State of Utah
DEPARTMENT OF NATURAL RESOURCES
DIVISION OF OIL, GAS AND MINING

Re: N98-41-2-1 ACT/007/012 #2

BACKGROUND INFORMATION:

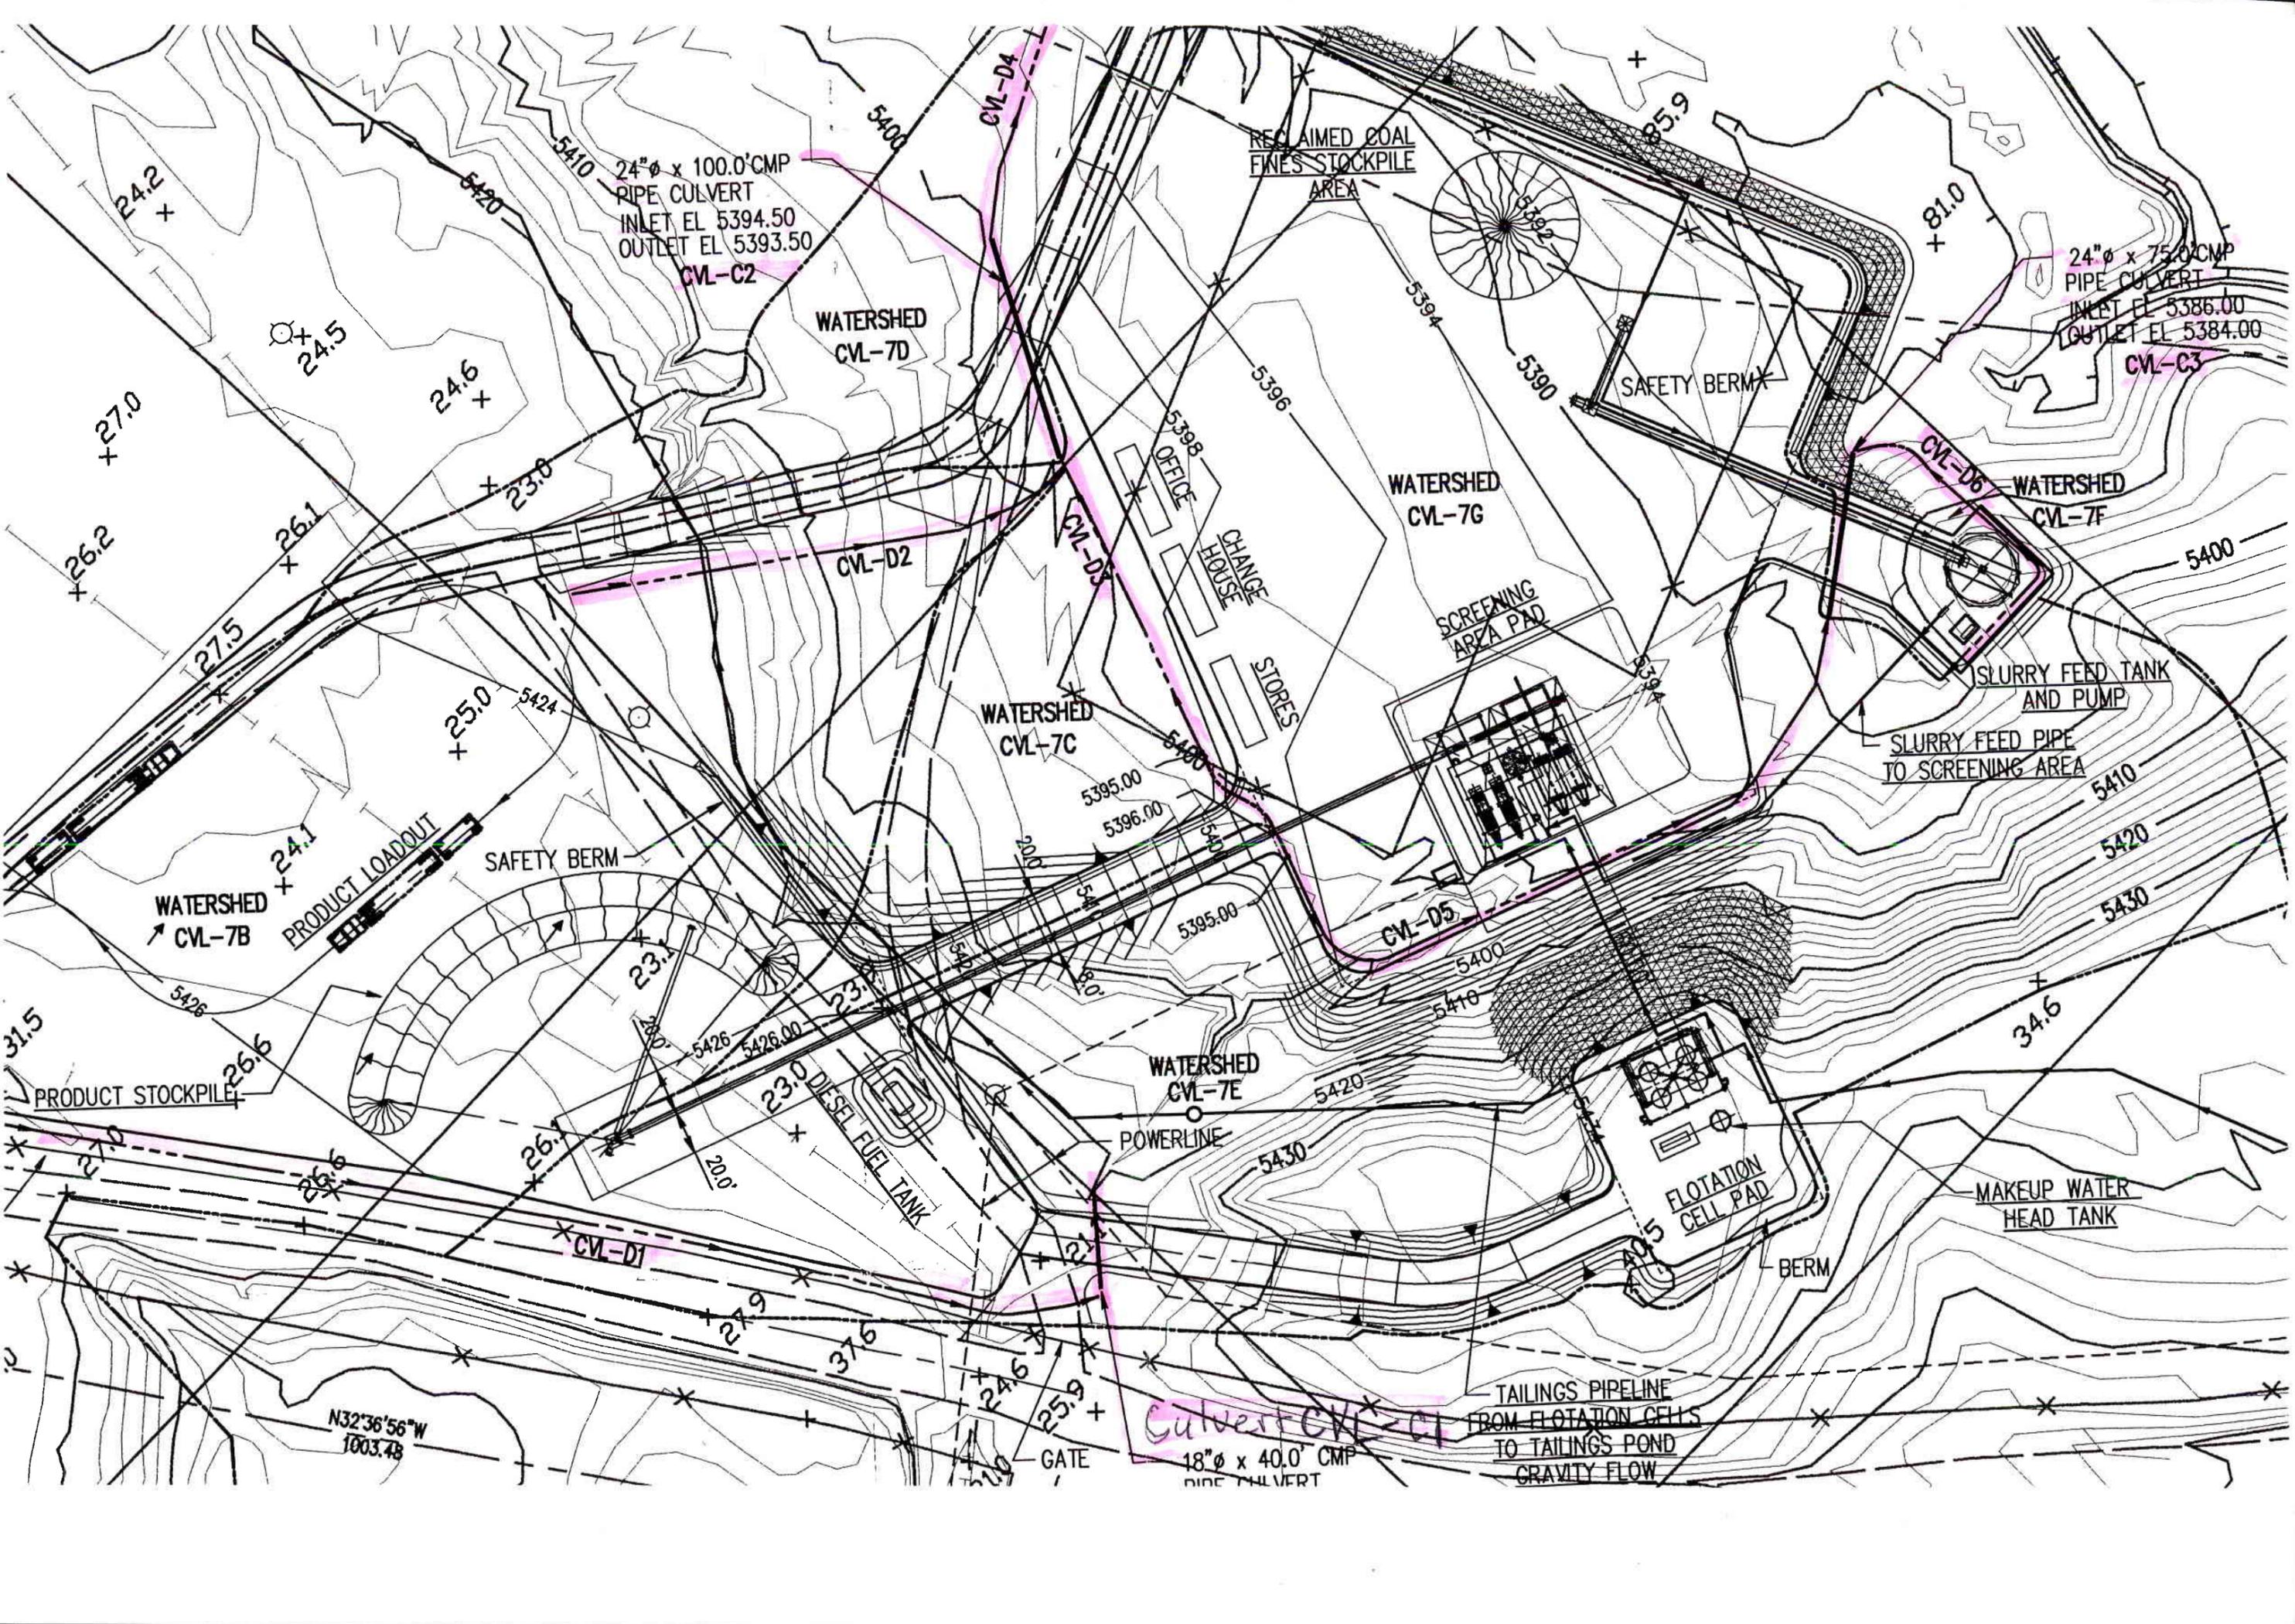
During the inspection, water was being drained from the slurry feed tank into an undesigned ditch leading to the slurry pond. I estimated about 1-2 cfs was flowing through this ditch, and it had eroded about two feet deep.

The designs show culvert CVL-C3 being 24 inches in diameter, but the culvert that was installed had a diameter of 12 inches. It appeared water from the operations had been flowing through the lowermost part of ditch CVL-D5 to this culvert, and there was black foam at least one foot deep on the upstream side of the culvert. It appeared the culvert had not been able to handle the flow and that water and foam had backed up. The operation and reclamation plan does not indicate any of the diversions would be used for water from the operations; they were to be used strictly for precipitation runoff control. Therefore, these diversions were not designed with all aspects of the operation in mind.

Ditches CVL-D1, CVL-D4, CVL-D3, and the part of CVL-D5 below the flotation cell pad were not built. In the place where CVL-D4 was supposed to be was a coal stockpile. In the relatively flat areas of CVL-D1 and CVL-D3, there was no real drainage control other than sheet flow.

There was no culvert installed where CVL-C2 was supposed to be. Instead, a 12-inch culvert (rather than 24) had been installed under the road paralleling where ditch CVL-D3 was supposed to be. Culvert CVL-C1 was not installed.

The drainage designs failed to take into account a culvert under the county road near the gate at the main entrance. This eventually led to water being diverted to the ditch along the slurry pipeline road to the west and this ditch failing. Straw bales were present in the area to treat the runoff.

1. Water from the operations was being routed through drainage control structures not designed to carry this water. This led to a backup of water and foam at one culvert and an undesigned ditch cutting at least two feet deep.
2. Several of the designed ditches were not built.

3. One culvert was not installed and one was not installed in the position shown in the plan. Both installed culverts were supposed to be 24 inches in diameter, but both were 12 inches.
4. The drainage designs did not take into account a culvert under the county road. This lead to drainage going down a ditch that was not designed to carry this additional water and to failure of the ditch.
